METROPOLITAN GOVERNMENT OF NASHVILLE AND DAVIDSON COUNTY

STAFF RECOMMENDATION
1314 Lillian Street
October 16, 2013

Application: Demolition; New construction-infill
District: Lockeland Springs-East End Neighborhood Conservation Zoning Overlay
Council District: 06
Map and Parcel Number: 08313015200
Applicant: Jamie Pfeffer, Pfeffer Torode Architecture
Project Lead: Sean Alexander, sean.alexander@nashville.gov

1 SITE / ROOF PLAN
 SCALE 1/16" = 1'-0"

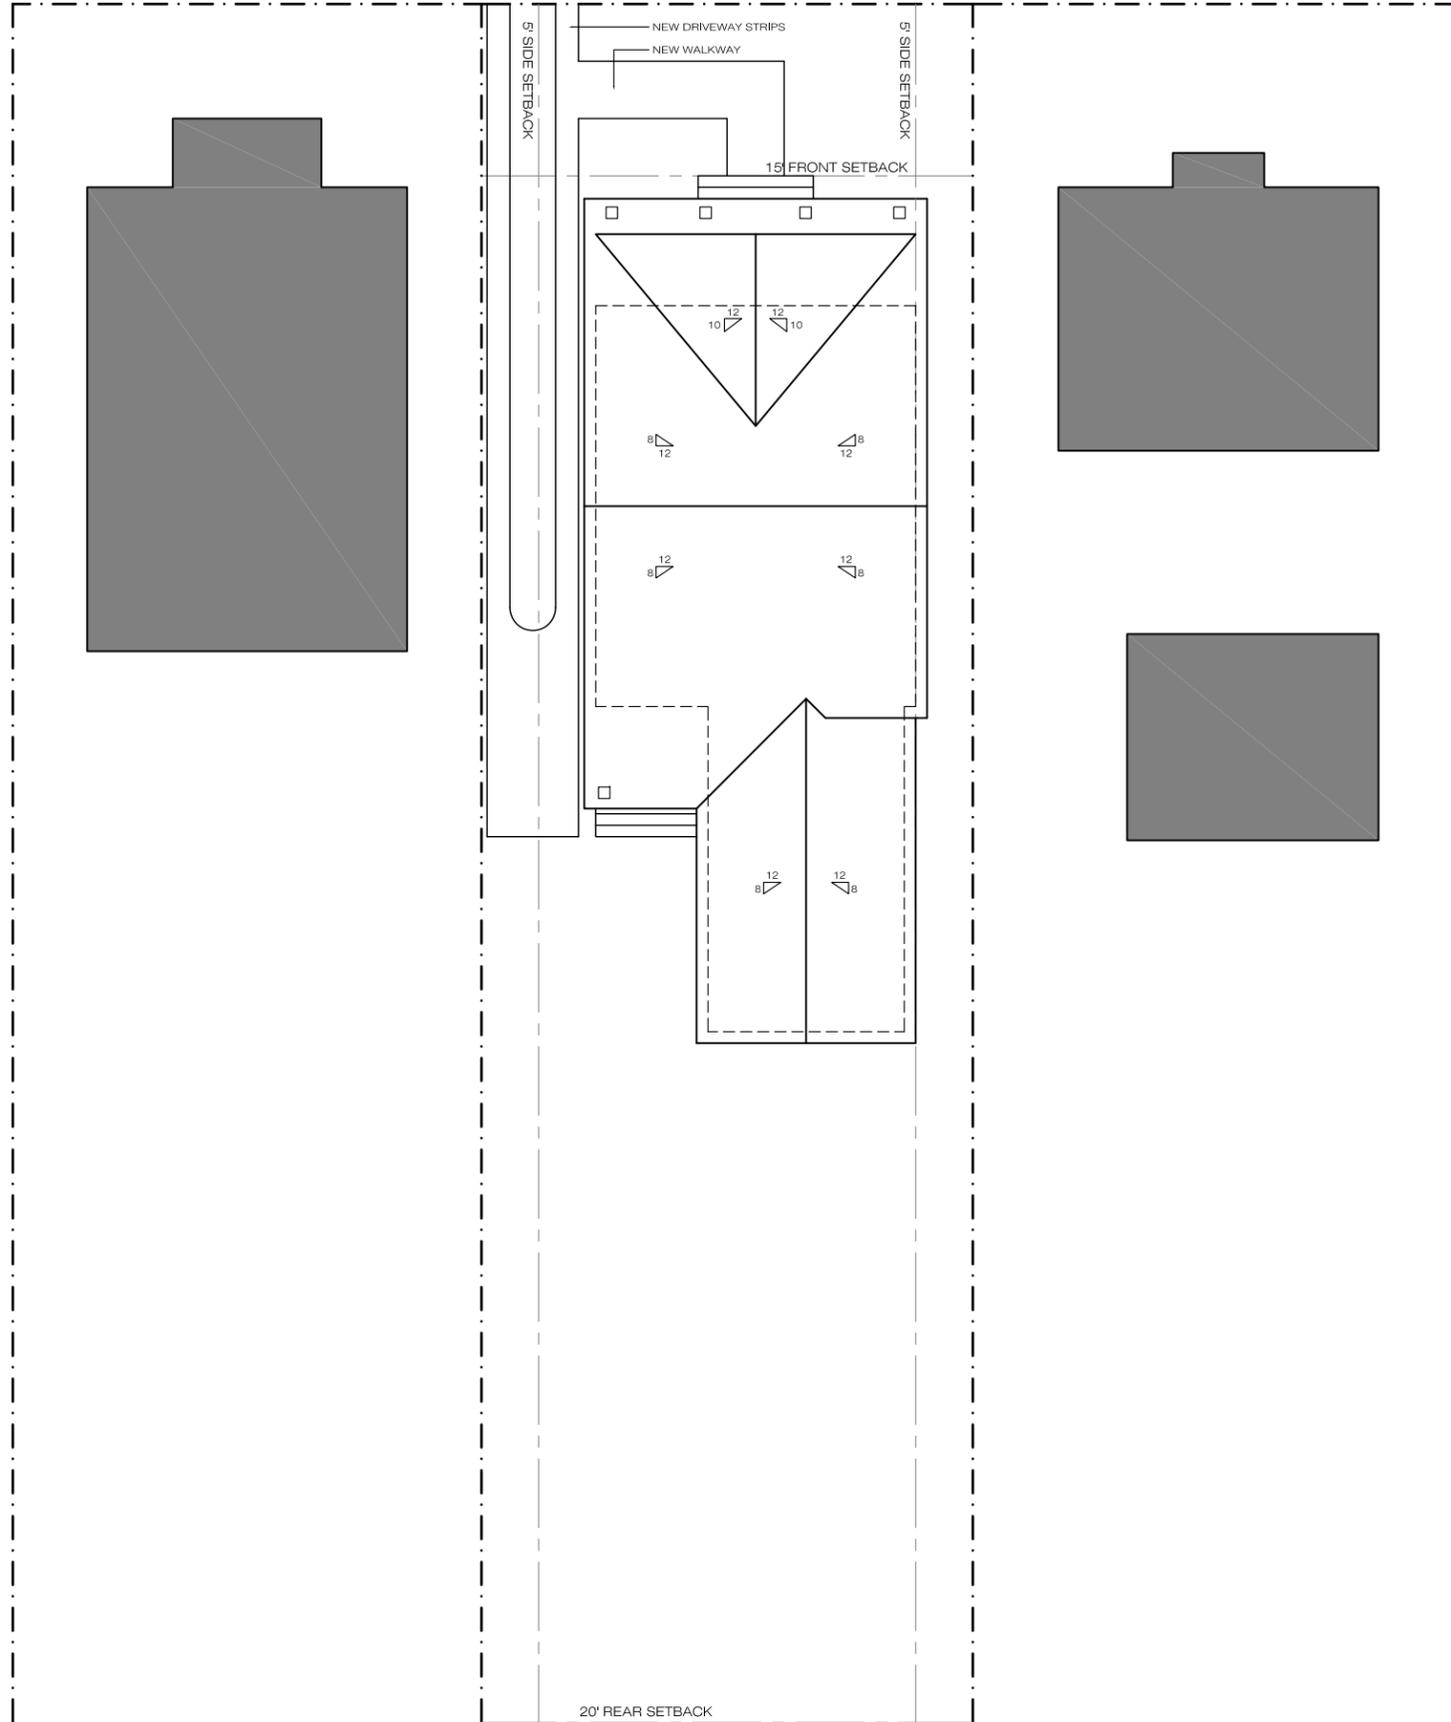
The new building will have a front setback of fifteen feet (15') to the leading edge of the front porch. This will be five feet (5') shorter than the setbacks of recently constructed houses on the street, but is six feet deeper (6') than the remaining non-contributing buildings. Staff finds that this setback is appropriate given the character of the context, and may facilitate the appearance of gradual setback variation with subsequent infill on the block.

The side setbacks will be five feet (5') on the left and ten feet (10') on the right, with a driveway running along the right side of the property. These setbacks are compatible with those of the surrounding context and will maintain the rhythm of spacing established by existing buildings.

The front façade of the building will be match the orientation of the existing buildings nearby, with driveway running along the right side of the building to the rear of the house. A new sidewalk will connect the front porch to the driveway. The orientation and paving are appropriate for this lot because there is no front sidewalk along the street and no alley access at the rear.

The location of the HVAC and other utilities was not noted. Staff asks that the HVAC be located on the rear façade, or on a side façade beyond the midpoint of the house. The project meets section II.B.9.

Staff recommends approval of the application to demolish a non-contributing building and construct a new one and one-half story house at 1314 Lillian Street with the conditions that Staff approve the selection of specific windows and doors and the location of exterior HVAC units, finding the proposal to meet the design guidelines for the Lockeland Springs-East End Neighborhood Conservation Zoning Overlay.

A1.2

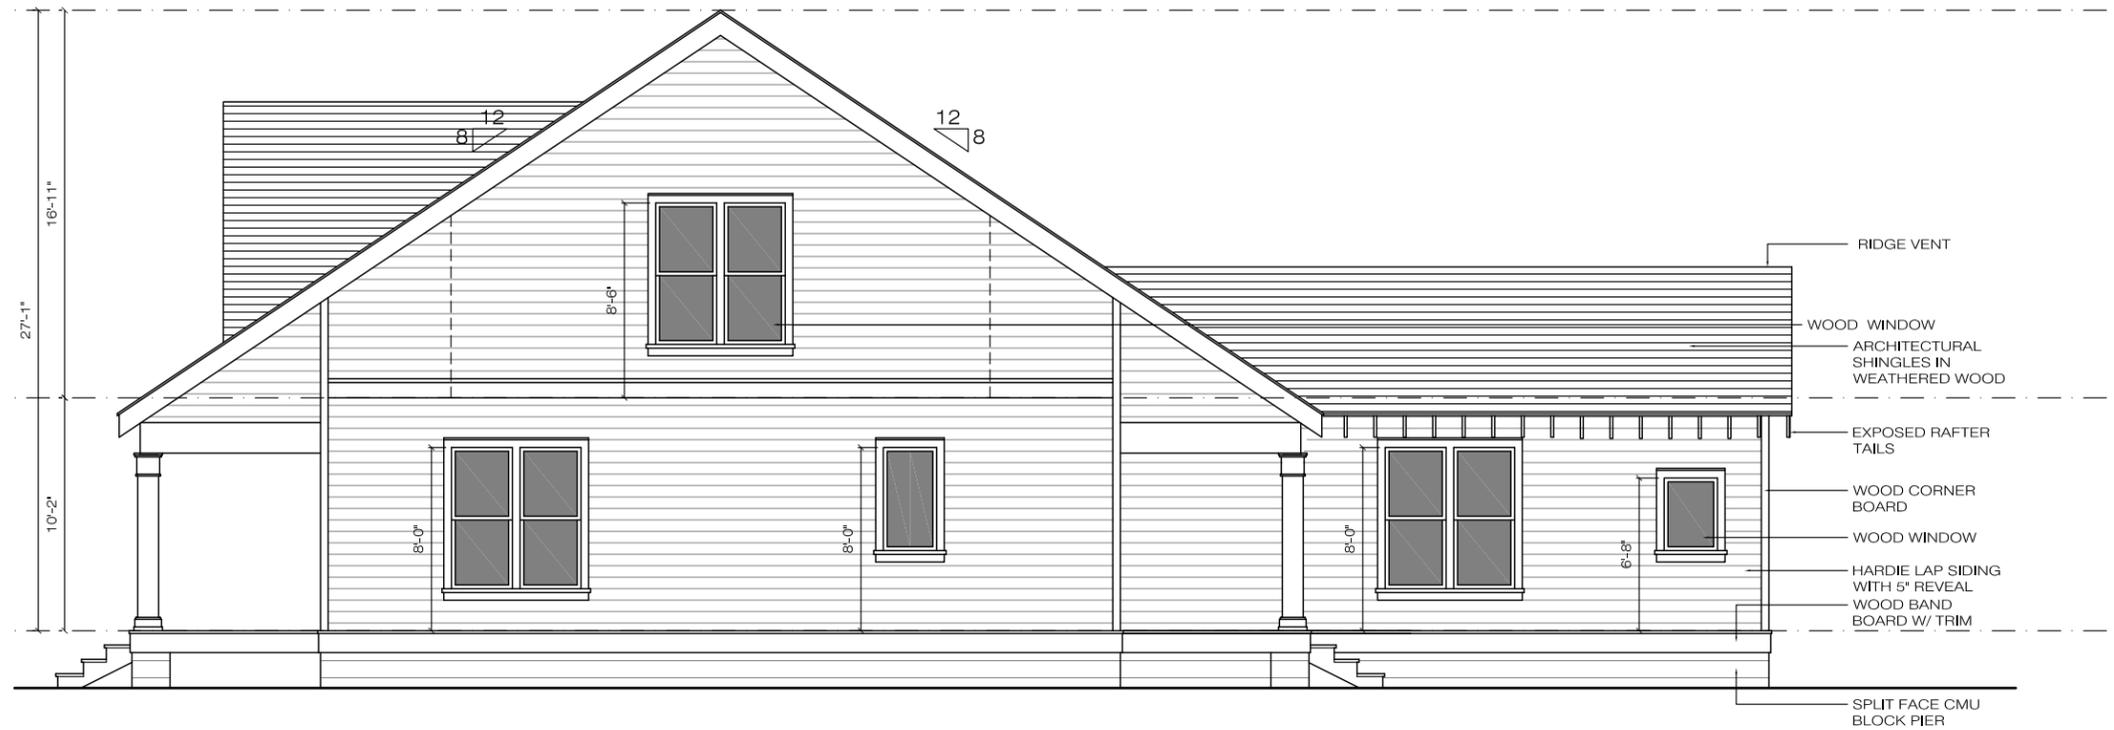
The new house will be one and one-half stories tall with a roof height of twenty-seven feet (27') above the finished floor level. The foundation height of the building will be eighteen inches (18") with a twelve inch (12") water-table band below the finished floor level. The total height of the building will be twenty-nine feet, six inches (29'-6") from peak to grade.

The new building will primarily be clad in smooth face cement fiberboard with a reveal of five inches (5"). The trim will be wood. The foundation will be split-faced concrete block, and the roof will be architectural fiberglass shingles in "weathered wood" color.

The primary roof of the new house will be a side-oriented gable with a pitch of 8:12. A front-gabled dormer will have the same pitch. This roof form and pitch are compatible with those of historic houses nearby. No roof-penetrating chimneys or skylights are indicated.

Proportion and Rhythm of Openings: The windows on the proposed new house are all generally twice as tall as they are wide, thereby meeting the historic proportions of openings. There are no large expanses of wall space without a window or door opening. Staff finds the project's proportion and rhythm of openings to meet Section II.B.7.
